ADDENDUM No. 1

ITB No. 4433

FERDON WELLS STORM SEWER REHABILITATION PROJECT

Plans Sheets 4 & 7 These plan sheets shall be removed and replaced with the attached plans sheets #4 and 7. The significant changes to these plans sheets include the following:

- NOTES:
1. FRONT EDGE OF INLET CASTING SHALL BE FLUSH WITH FRONT EDGE OF GUTTER (EDGE-OF-METAL)
 2. 2' SUMP REQUIRED ON ALL DRAINAGE STRUCTURES.

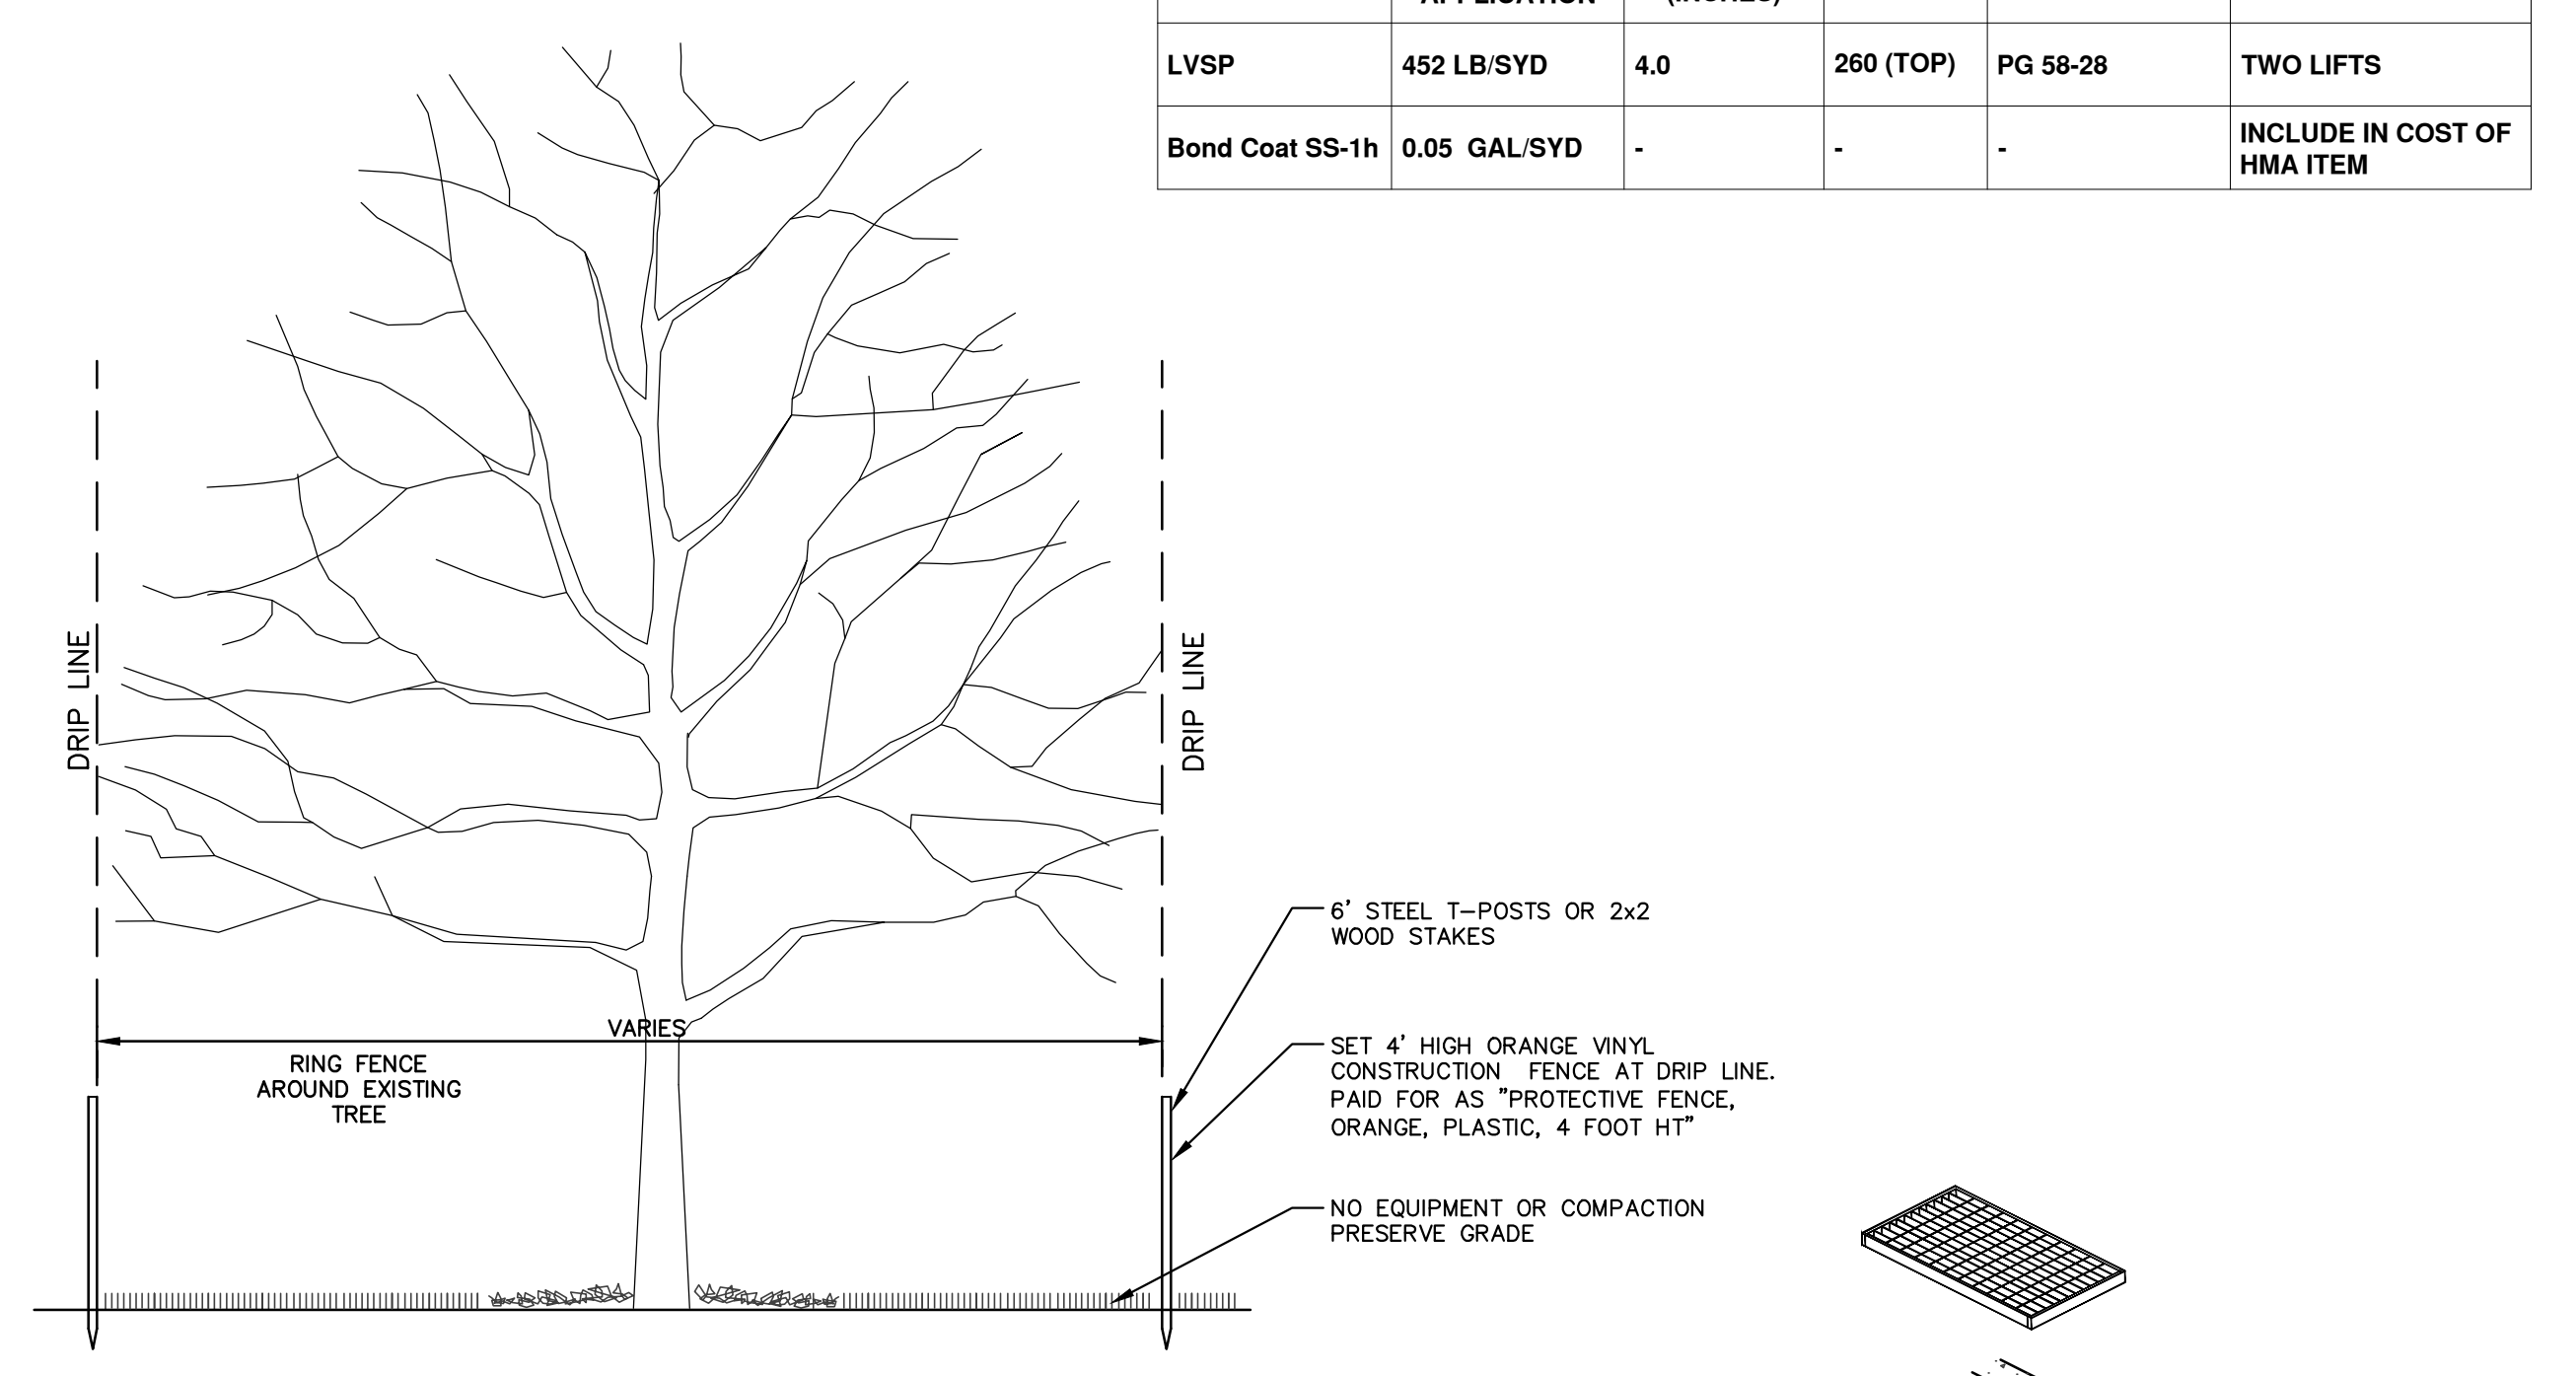
On plan sheet #4, the 10 inch sand subbase, CIP is shown to consist of MDOT Granular Material Class II, Modified.

DRAWING NO. 2014044-7

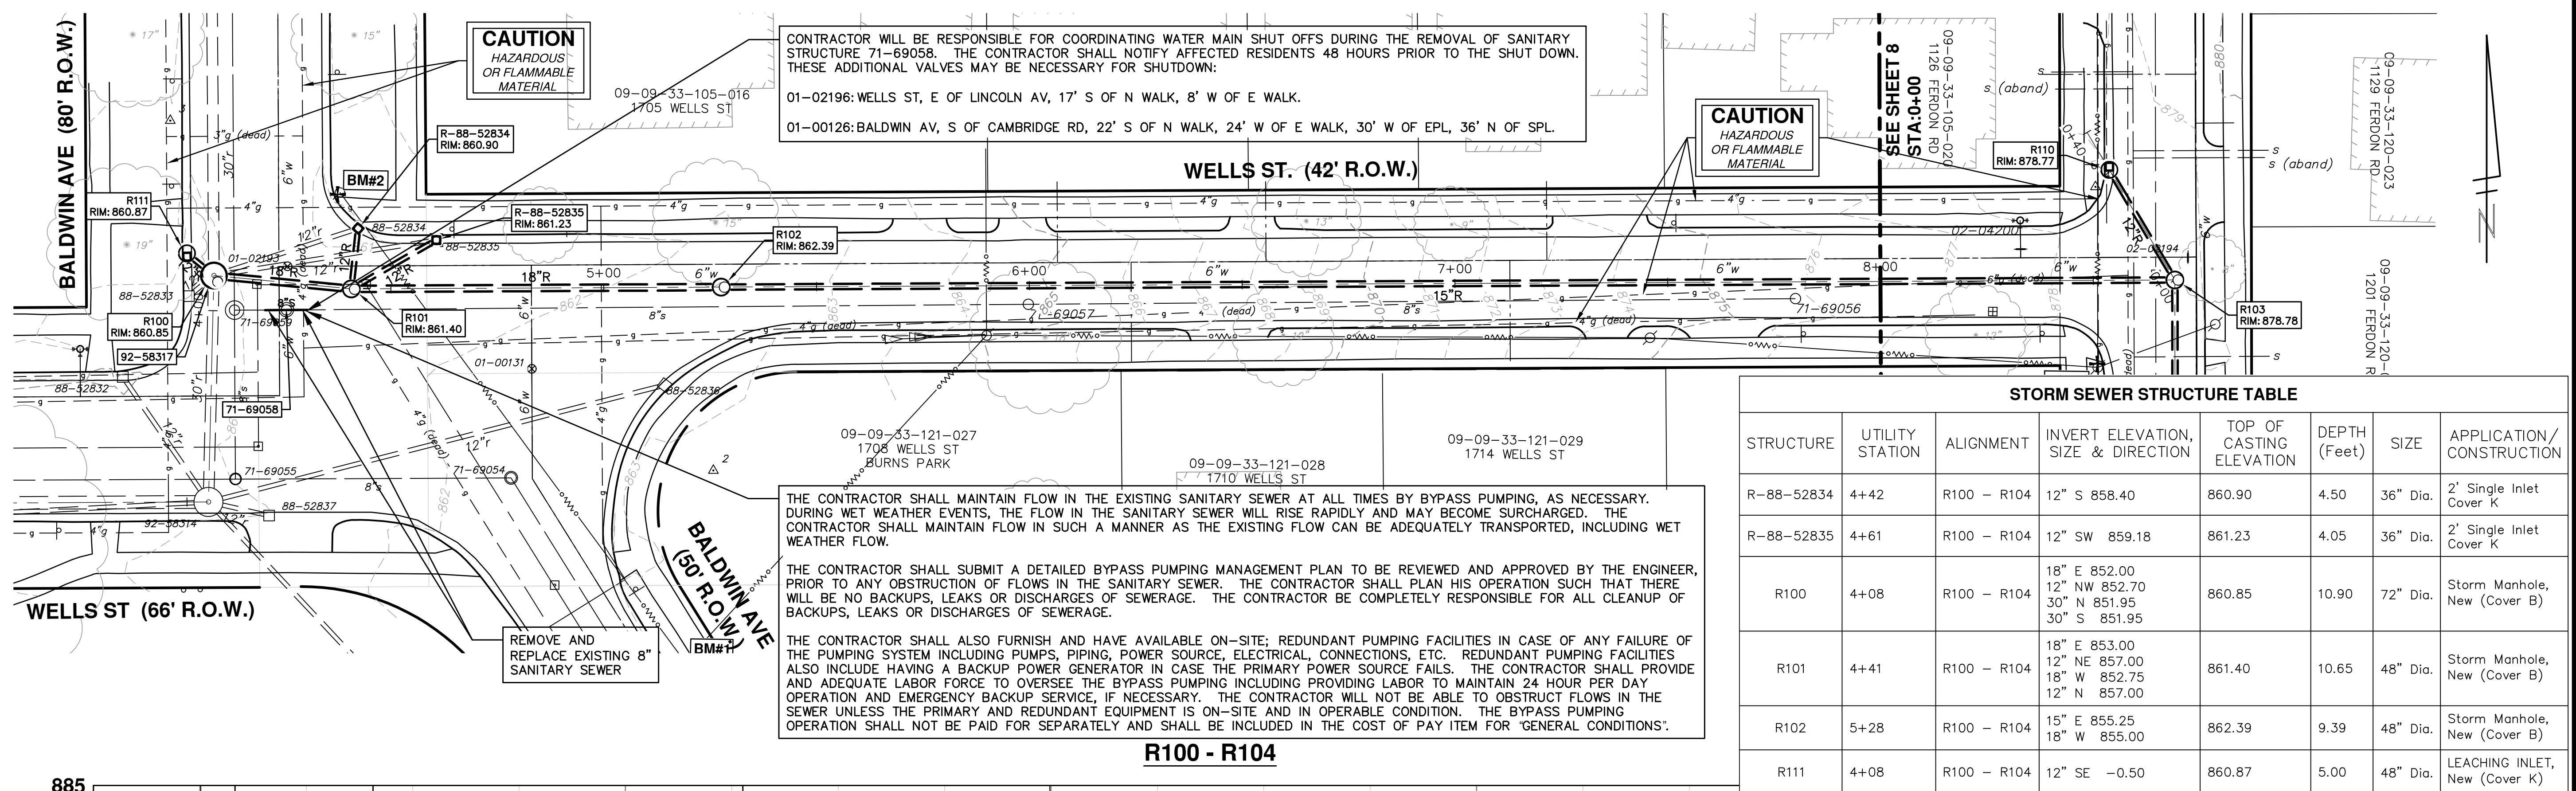
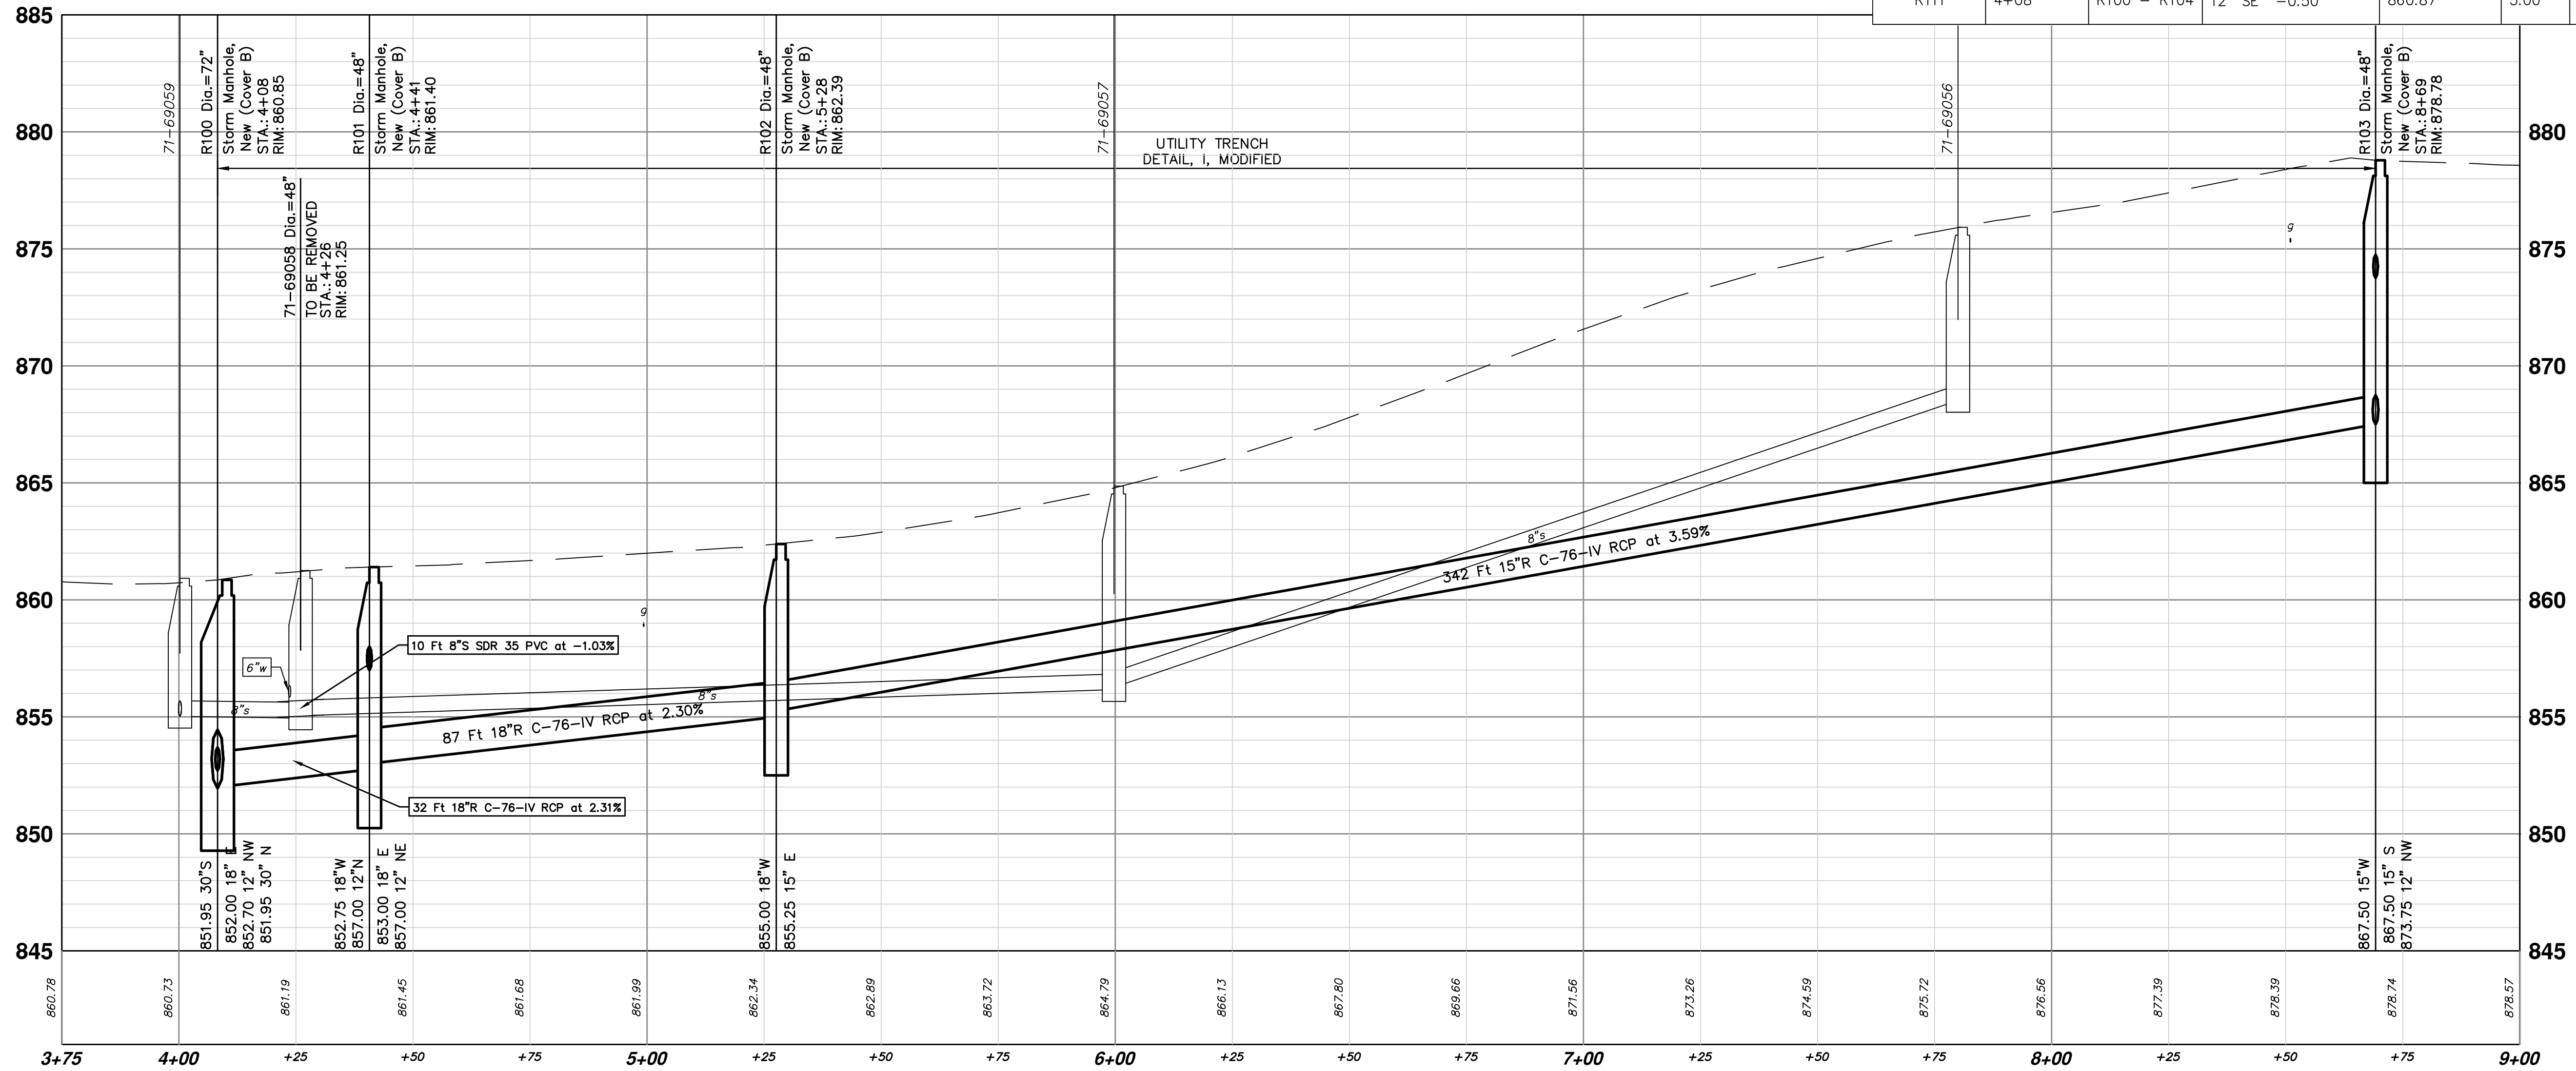
On plan sheet #7, a note about bypass pumping was added.
